City of Portland, Oregon
Bureau of Development Services
Land Use Services
FROM CONCEPT TO CONSTRUCTION

MEMORANDUM

Date: December 4, 2017
To: Carol Gossett - OMSI
From: Benjamin Nielsen, Development Review
503-823-7812
Re: EA 17-243925 DA - OMSI Master Plan
Design Advice Request Summary Memo October 26, 2017

Figure - 4.1.1.A - Phase 1 Plan

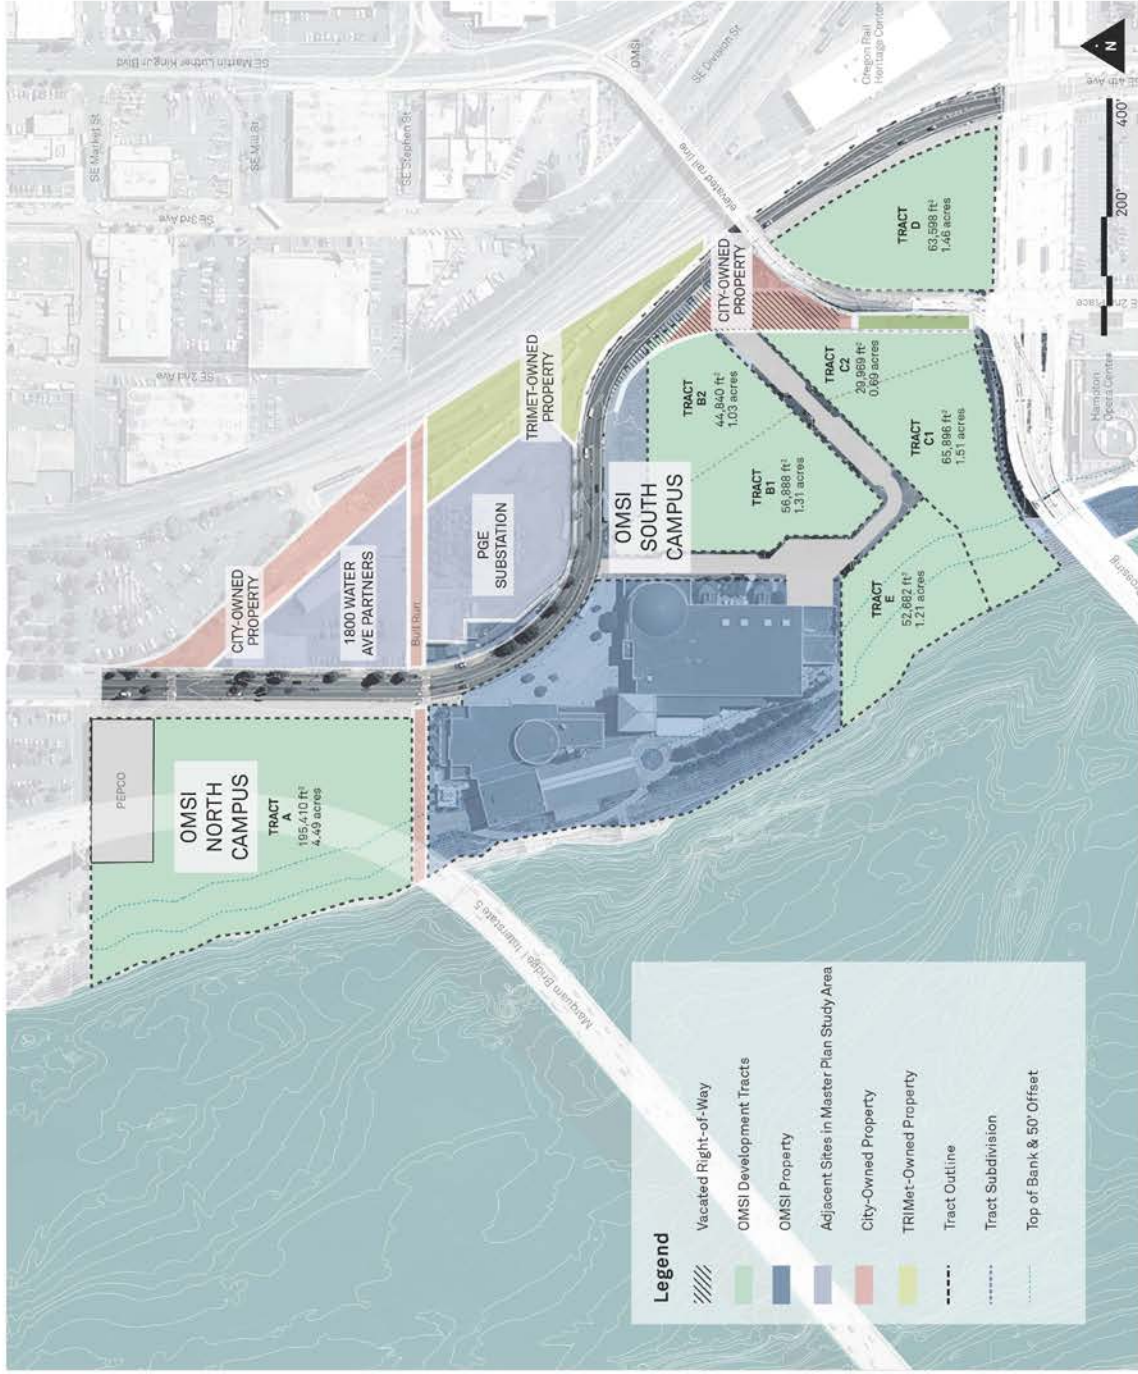
- Currently-indicated building massing forms a real barrier along SW Water Ave, and development is turning its back on the rest of the Eastside. Orient upper story massing along Water Ave to allow visual connections from east to west to the river as well as spacing for light and air between towers at the ground level pedestrian passageways.
- Tract C2 seems like a very oddly-sized and shaped parcel to have such a tall building massing on it.

- The large parking garage proposed for Tract D, adjacent to the intersection of two mass transit stations, conflicts with the stated values of the OMSI master plan. It's not that parking cannot be located here, but the edges of any building here need to be lined with active uses.
